**TOWN OF OCEAN RIDGE
PLANNING & ZONING REGULAR MEETING
AGENDA**

To: Planning & Zoning Board Members
From: **Corey O’Gorman, Town Planner**
Meeting Date: September 17, 2024
Subject: 5920 N Ocean Blvd – Development Plan Review

PLAN REVIEW REPORT
5920 N Ocean Blvd
REV 5 - Summary

PLAN REVIEW REPORT
5920 N Ocean Blvd
10/16/2023 REV 1

SHEET NUMBER:
A1.1

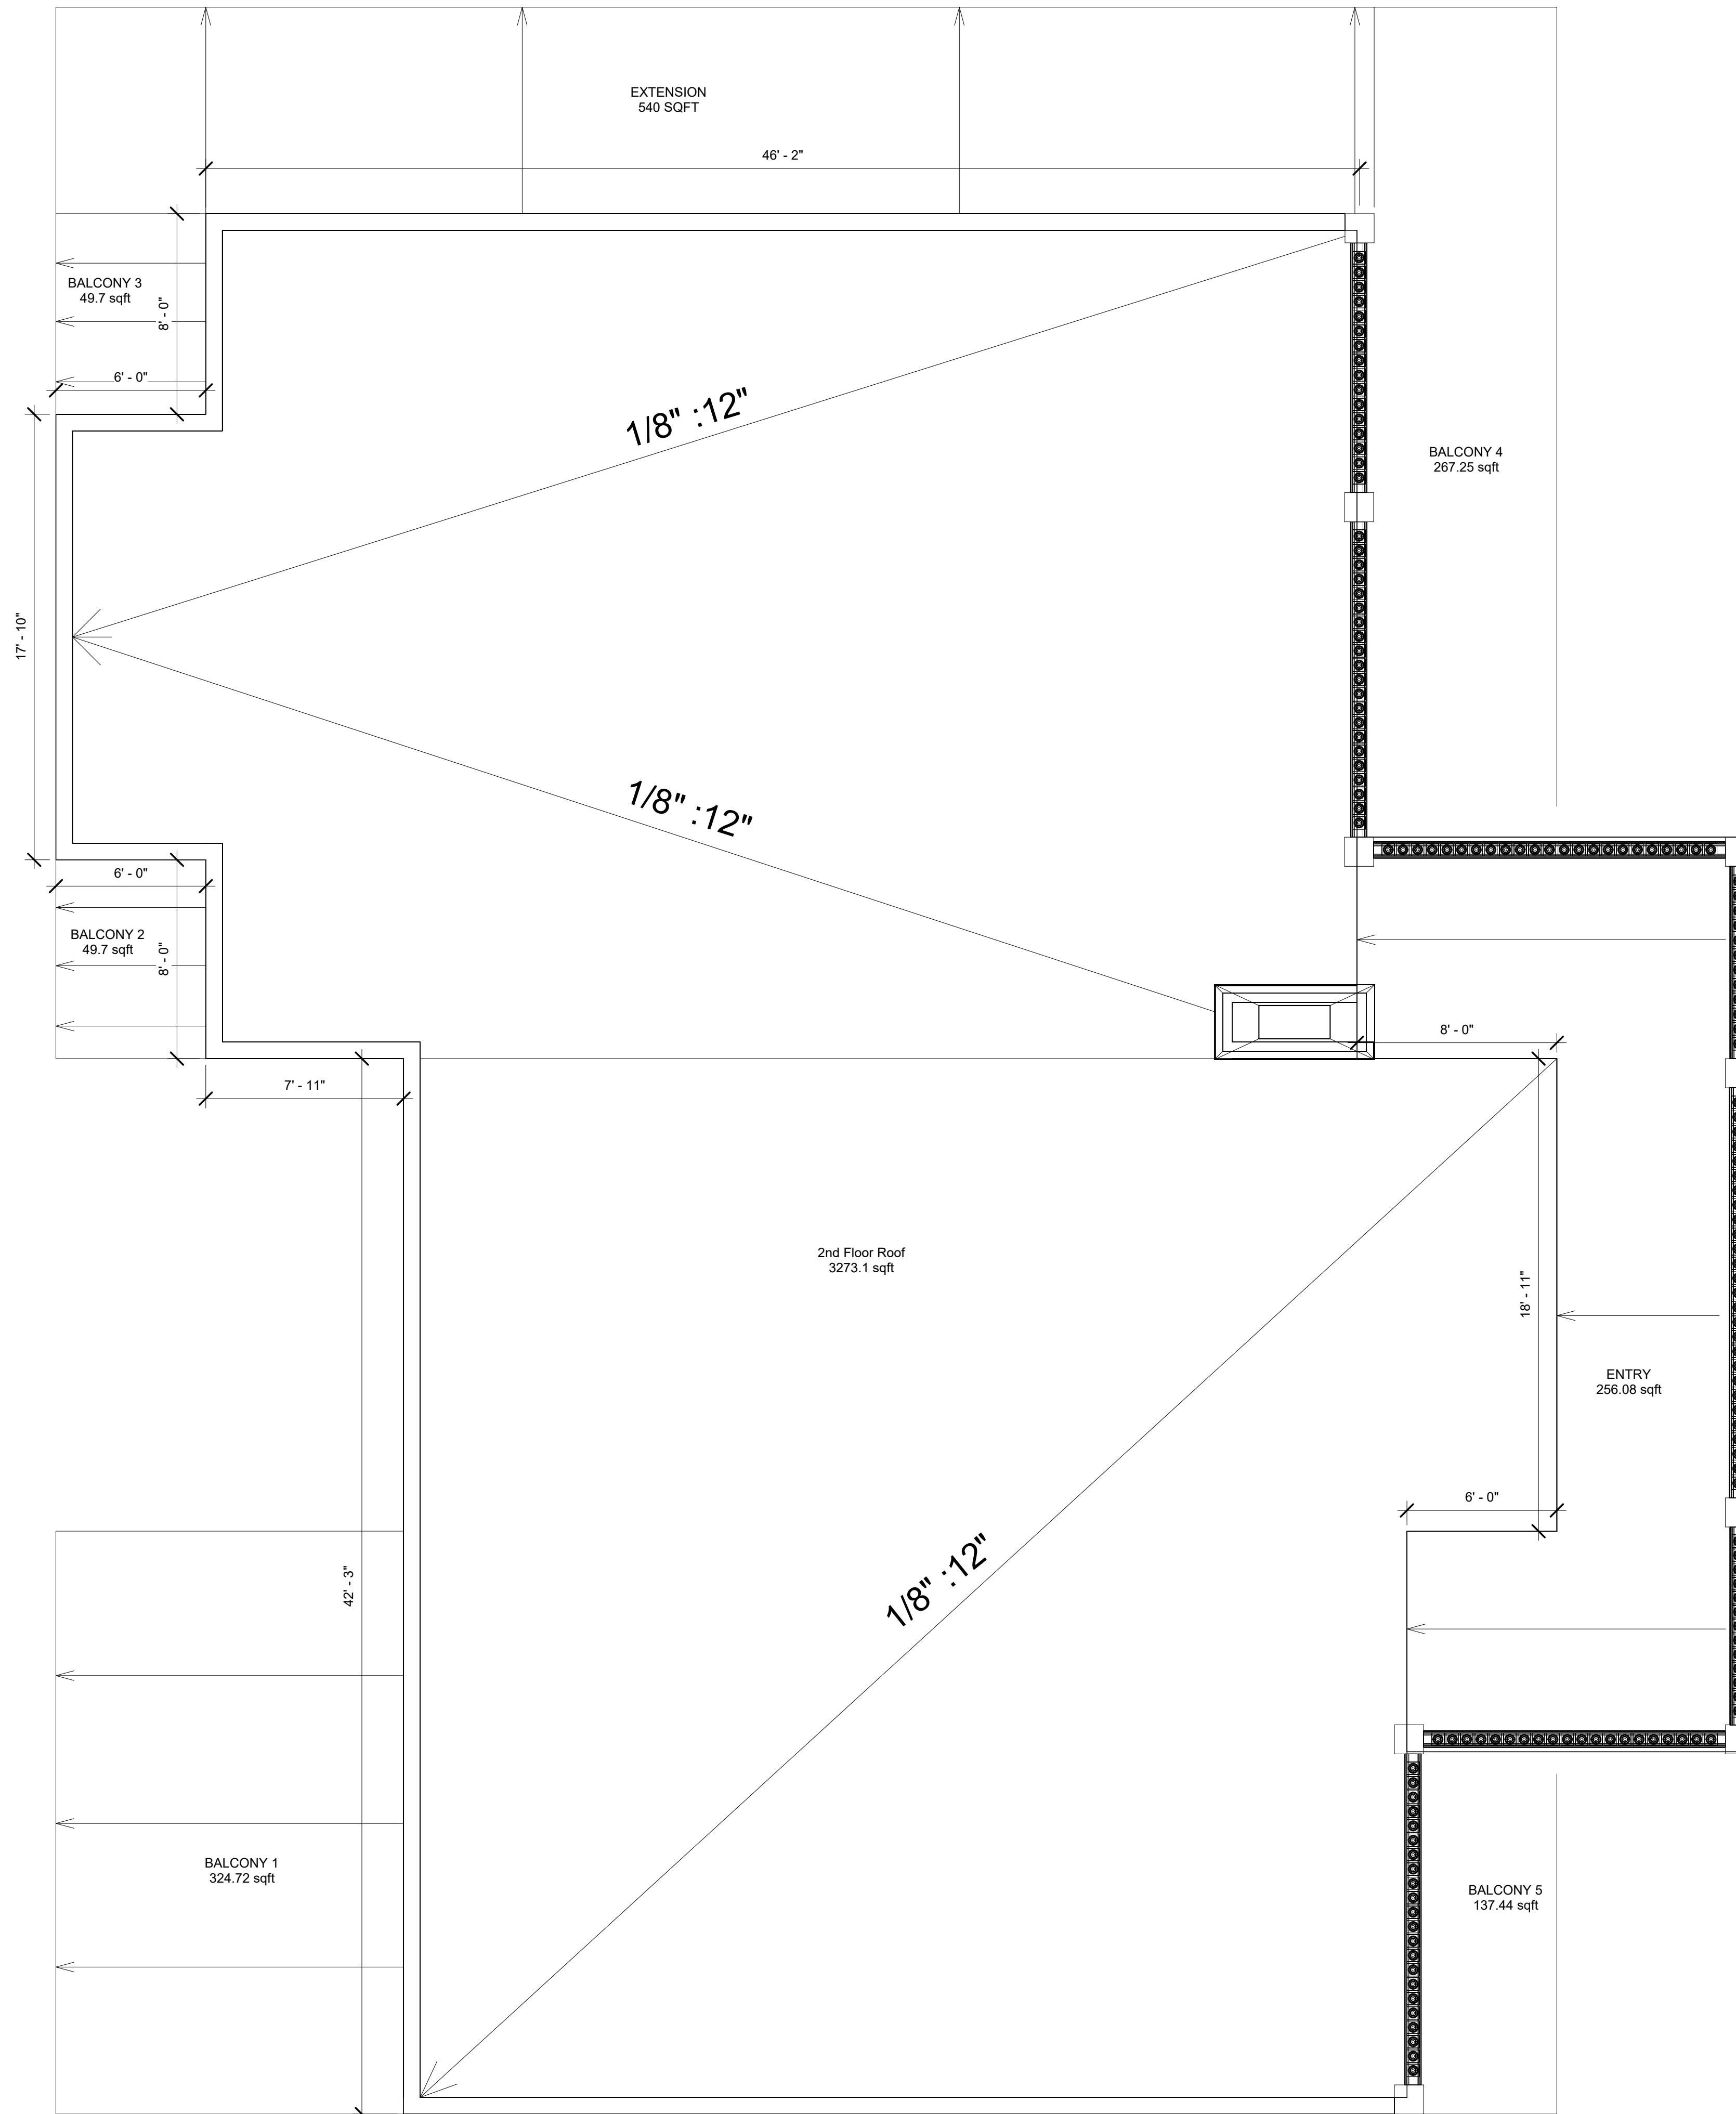
~~**REV 4: The plans were revised however a note remains on Sheet A1.1 noting the location of the roof access stairs. Please delete this note. THIS COMMENT IS ADDRESSED.**~~

~~**Section 64-1(f) limits the flat roof usable area to 15% of the total floor area, is limited to a height of 14' above the finished floor, and this calculation must be provided to ensure compliance. Please revise Sheet A1.1 to provide the roof area and flat roof area calculation.**~~

~~**REV 4: The response to this comment states that calculations of the usable flat area at 14' is shown on the plans, but were not found on any sheets of the resubmittal. Please either specify what sheet and where the revisions are located or provide the calculations. THIS COMMENT IS ADDRESSED.**~~

SHEET NUMBER
A 2.1

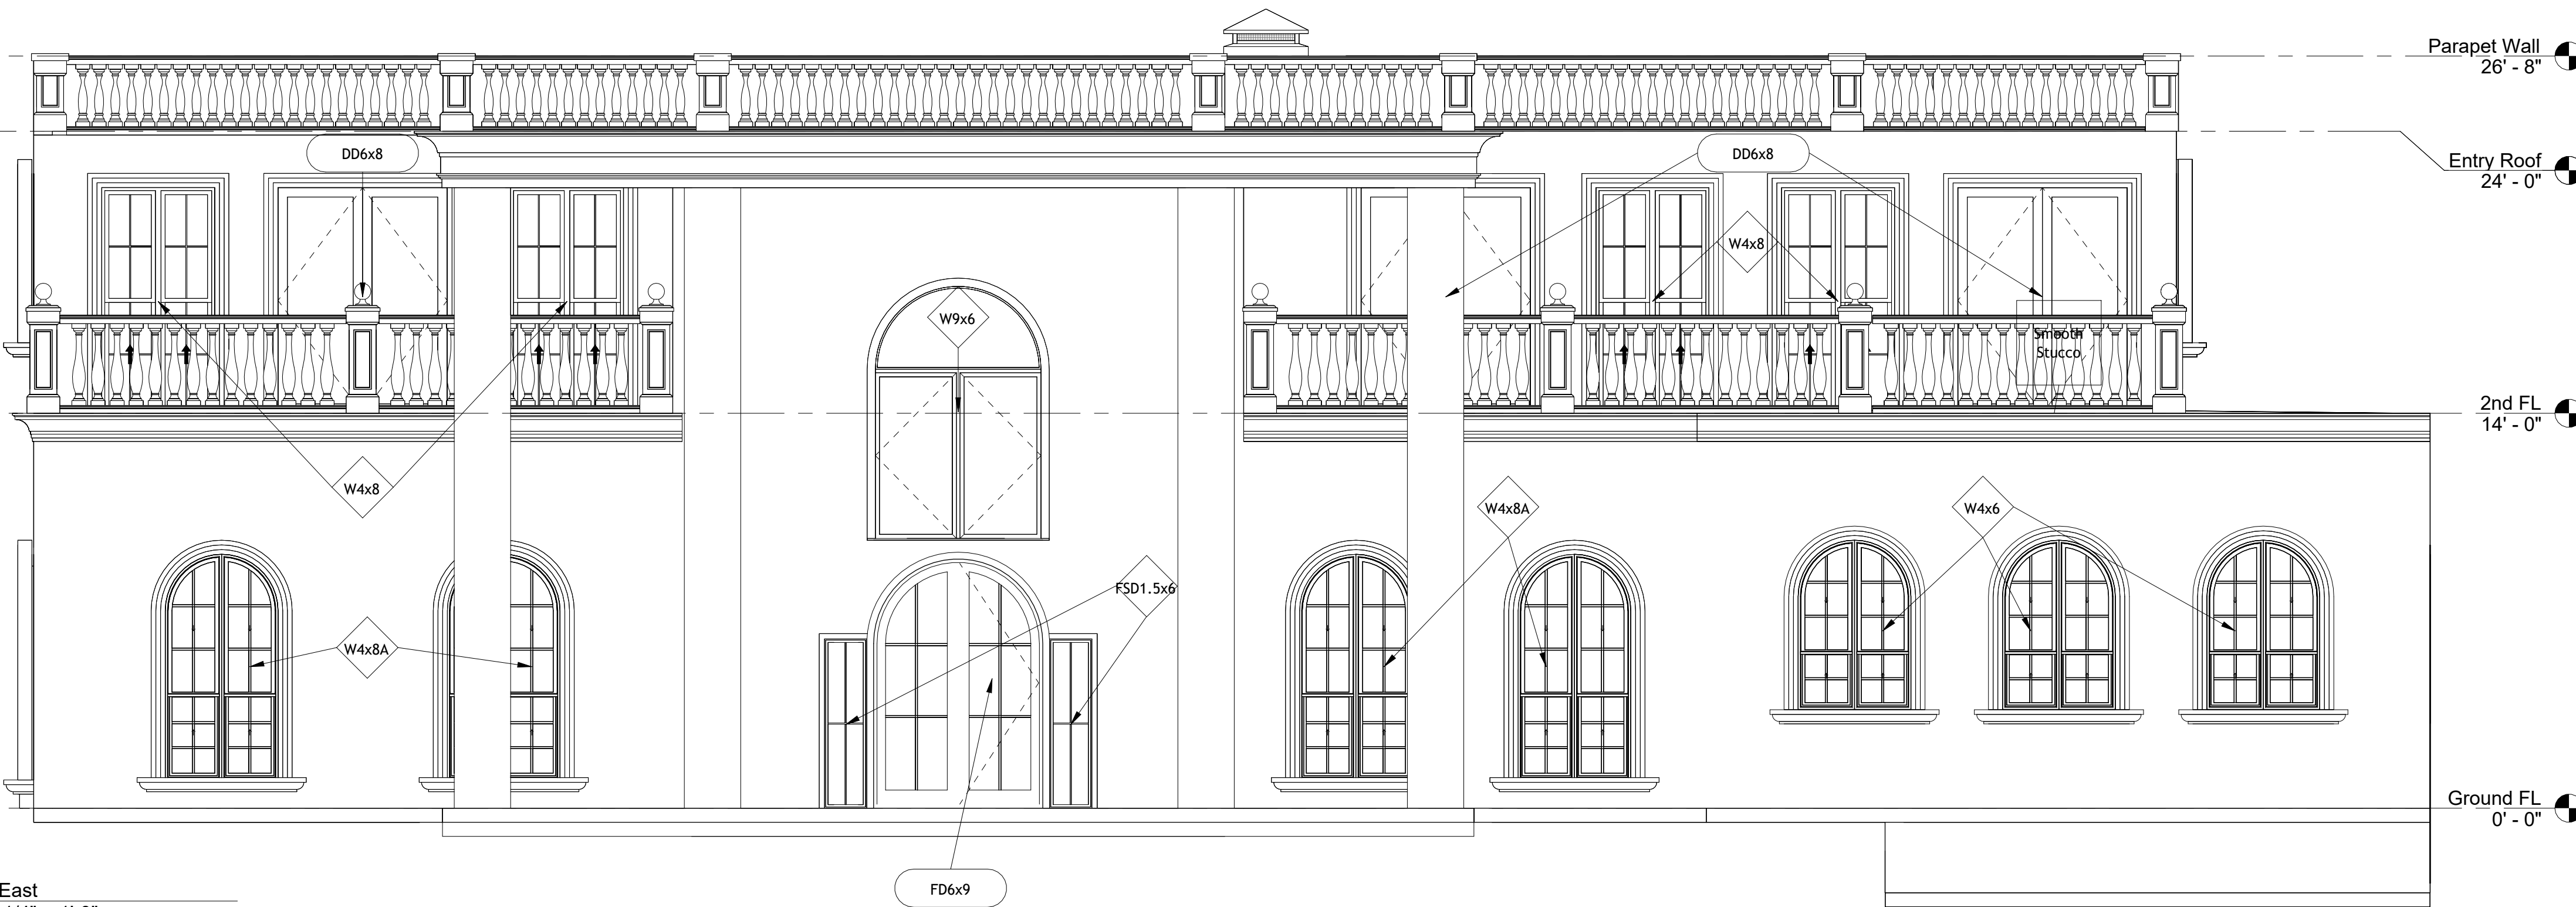
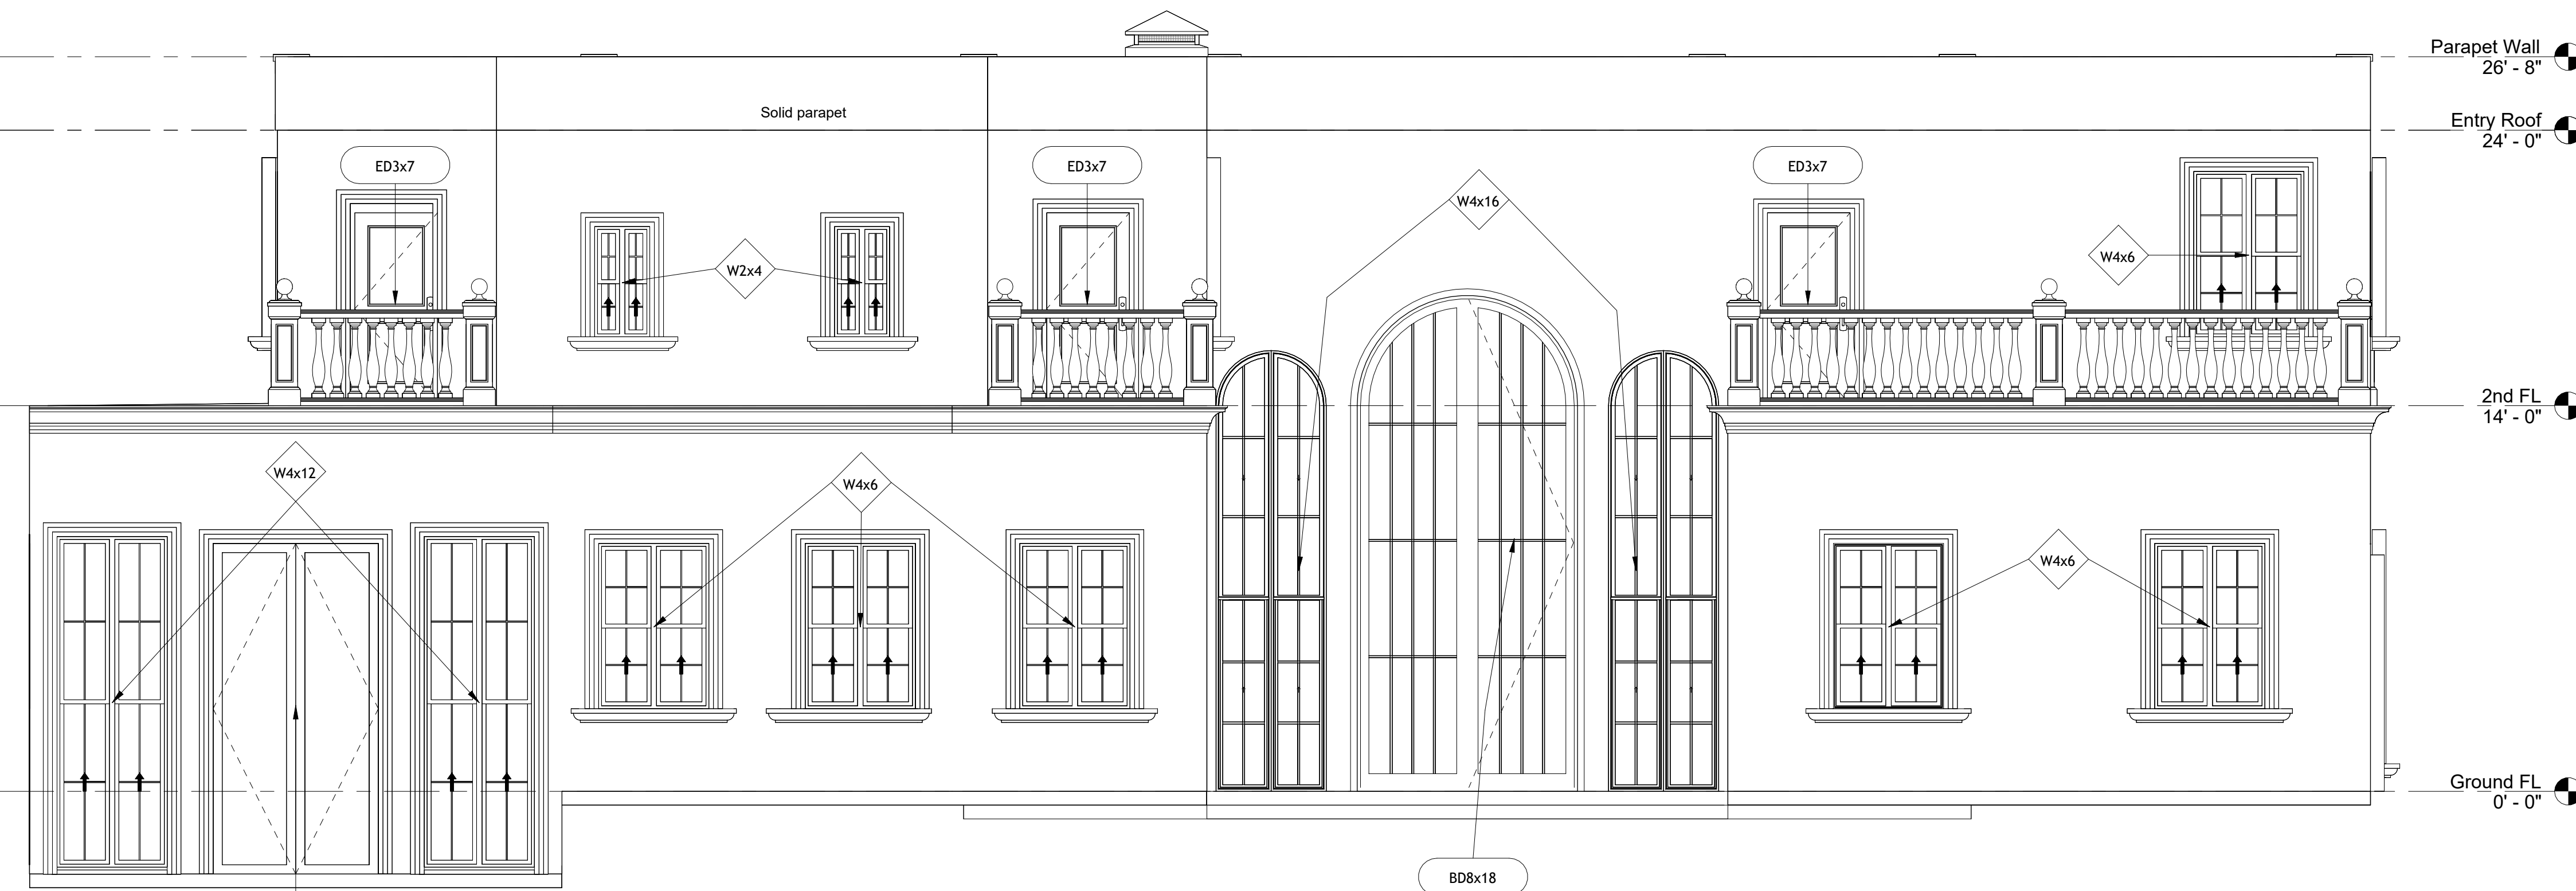
~~Comment: Please revise elevation sheets A-2.0 and A2.1 to provide the calculations and information necessary to ensure compliance with this section. This comment is partially addressed. The elevation sheets are revised to show a percentage of opening, but do not provide calculations. Also, it appears that there are areas of the exterior walls that do not comply with the articulation requirements. Please revise the elevations to clearly show compliance with both the windows and door coverage requirements, and the articulation requirements for all four elevations. This comment was not addressed. Areas on the north and south elevations on sheet A2.0, as well as a portion of the west elevation on sheet A2.1 do not appear to comply with the articulation requirement. Please revise sheets A2.0 and A2.1 to demonstrate compliance.~~

~~REV 4: Although the response states that articulation was added, this comment has not been addressed, and the north/south elevations do not appear to comply with the town code. Please provide the revised plans demonstrating compliance with the articulation requirements specified above. THIS COMMENT WAS ADDRESSED. HOWEVER THE ARTICULATION PROPOSED ON THE NORTH SIDE OF THE BUILDING INCLUDING THE WINDOW DOOR AND ROOF TRIM,~~

~~Comment: Sheet A 2.1 and Sheet A 3.0 appear to show a parapet of 3'6" or 42", there is no dimension on the rooftop/balcony balustrade, it is not clear if there is any flat roof usable areas, and it is not clear if there is any mechanical equipment on the roof. Please provide additional details to ensure compliance with the section regarding roof requirements. **The revisions appear to comply with this comment, however written reply #5 states that the upper roof is accessible via stairs from the lower deck, but no steps are shown. Please clarify this comment. This comment was clarified by the latest revision that shows circular stairs accessing the roof on sheets A1.0, A1.1 and A2.0 and A2.1, however Town Code Section 67-37 prohibits access to a flat roof usable area above 14', and the stairs must be removed. Please revise all applicable sheets to delete stairs.**~~

REV 4: ~~Overall building height and parapet heights have been revised, however the plans show several related design features that are not consistent with town code as follows:~~

~~The front elevation shows a balustrade feature on the 2nd floor tie beam which appears to substitute for the required parapet, and the columns exceed the allowable 32" height above the tie beam. As previously stated the flat roof structure is required to have a parapet that screens all authorized flat roof element so it must be a solid structure and cannot have openings as appear to be shown on the balustrades. Please revise the design to comply with this code requirement.~~

~~The tie beam for the roof structure covering the main entry on the front elevation exceeds the maximum height of 24' and the balustrades on top of this structure exceed the maximum height allowable and do not provide the screening required by parapets. Please revise the design to comply with this code requirement.~~

~~The town code permits authorized roof elements such as ventilation, chimneys, etc., but require that they are screened by the parapet. The elevations appear to show a chimney which exceeds the height of the parapet. Please revise the design to comply with this code requirement. THIS COMMENT IS~~

AND THE EMBLEM ARE NOT PERMITTED TO ENCROACH ANY FURTHER INTO THE SETBACK THAN THE EXISTING WALL. A CONDITION OF APPROVAL IS THAT THE NORTH BUILDING ELEVATION MUST BE REVISED TO BE FLUSH AGAINST THE EXISTING WALL IN THE FORM OF BANDING, STUCCO SCORE LINES ETC., RATHER THAN TRIM THAT EXTENDS BEYOND THE EXISTING ENCROACHMENT.

PARTIALLY ADDRESSED. A CONDITION OF APPROVAL IS THAT THE BALUSTRADES ON THE 2ND FLOOR FLAT ROOF AND THE COVERED ENTRY ARE REVISED TO NOT EXCEED 32" (THE COLUMN CAPS EXCEED THE 2'8" SHOWN) AND ARE REDESIGNED TO BE A SOLID SCREEN OF ALL AUTHORIZED ROOFTOP EQUIPMENT.
